FUEL FARM CONSTRUCTION PHASE

Subject: Update on Construction Items and Issues for the Bulk Fuel Storage and Dispensing System, Addison Airport

Subject: Construction Technical Change Order for the Bulk Fuel Storage and Dispensing System, Addison Airport

Subject: Construction Constructive Credit Change Order for the Bulk Fuel Storage and Dispensing System, Addison Airport

DETAIL 5
FENCE STRUCTURE

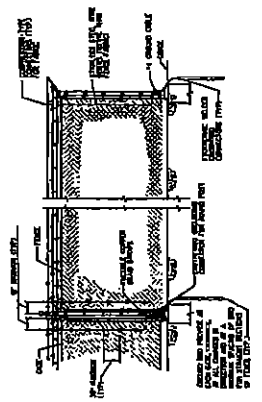
- 12) **Modify the 10' & 6' vinyl covered fence structure detail**
Change the 10' fence detail to 8' high with posts set at 7' on center instead of 10' and with top rail and bottom guy wire. The 8' fence remains black vinyl covered chain-link fence fabric with black slats. Change the post setting for the 6' black vinyl covered chain-link fence fabric with black slats and barbwire to 8' on center instead of 10'. Other chain link fencing remains as per plans. Shop drawings from the subcontractor will be reviewed and the additional cost must be determined.

Change the 10' fence detail to provide 4" diameter posts instead of 3", and set the posts at 7' on center, with top and middle rails and bottom guy wire. The 10' fence remains black vinyl covered chain-link fence fabric with black slats.

Change the post setting for the 6' black vinyl covered chain-link fence fabric with black slats and barbwire to 8' on center instead of 10'. Other chain link fencing remains as per plans. Shop drawings from the subcontractor will be reviewed and the additional cost must be determined.
